Access Compliance Report

Public Rights-of-Way

Intersection ID: N/A	Main Street: SOUTHGROVE_ST	Cross Street: WAVERLY_CENTER_DR	Location: NW
ADA ID: 9E32E2F8274F	Ramp Type: Perp	Initial Pass/Fail: Fail	Overall Compliance: No
Severity Score: 8.75			
Codes/Mitigation Info/Possible Solution		Field Measurements/Component Compliance

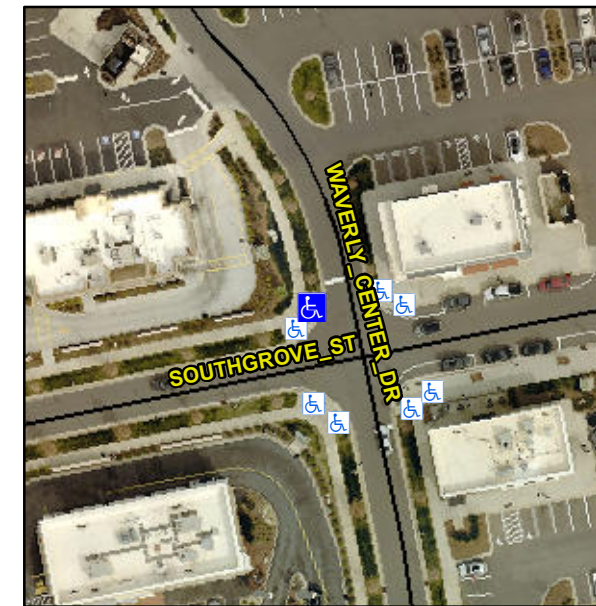
R304.5.1

Compliance	Description	Data	Compliance	Description	Data
N/A	Ramp Length (in)	95.0	Yes	Ramp Slope (%)	7.1
No	Ramp Width (in)	47.0	Yes	Ramp XSlope (%)	0.3
N/A	Flare Type LT	N/A	N/A	Flare Type RT	N/A
N/A	Flare Slope LT (%)	N/A	N/A	Flare Slope RT (%)	N/A
N/A	Flare Traversable LT?	N/A	N/A	Flare Traversable RT?	N/A
N/A	Landing Length (in)	N/A	N/A	DWS Provided?	N/A
N/A	Landing Width (in)	N/A	N/A	DWS Contrast?	N/A
N/A	Landing Slope (%)	N/A	N/A	DWS Length (in)	N/A
N/A	Landing X Slope (%)	N/A	N/A	DWS Full Width?	N/A
N/A	Landing Curb? (Y/N)	N/A	N/A	DWS Offset (in)	N/A
N/A	Shared Landing?	N/A			
N/A	Gutter Ponding?	N/A	N/A	Gutter Slope (%)	N/A
N/A	Gutter Lip Ht (in)	N/A	N/A	Gutter X Slope (%)	N/A
N/A	Painted X Walk1?	No	N/A	Painted X Walk2?	N/A
	X Walk 1 Direction	To E		X Walk 2 Direction	N/A
N/A	X Walk 1 Width (in)	N/A	N/A	X Walk 2 Width (in)	N/A
	X Walk 1 Slope (%)	2.3		X Walk 2 Slope (%)	N/A
	X Walk 1 X Slope (%)	2.6		X Walk 2 X Slope (%)	N/A

Remove & Replace Entire Ramp.
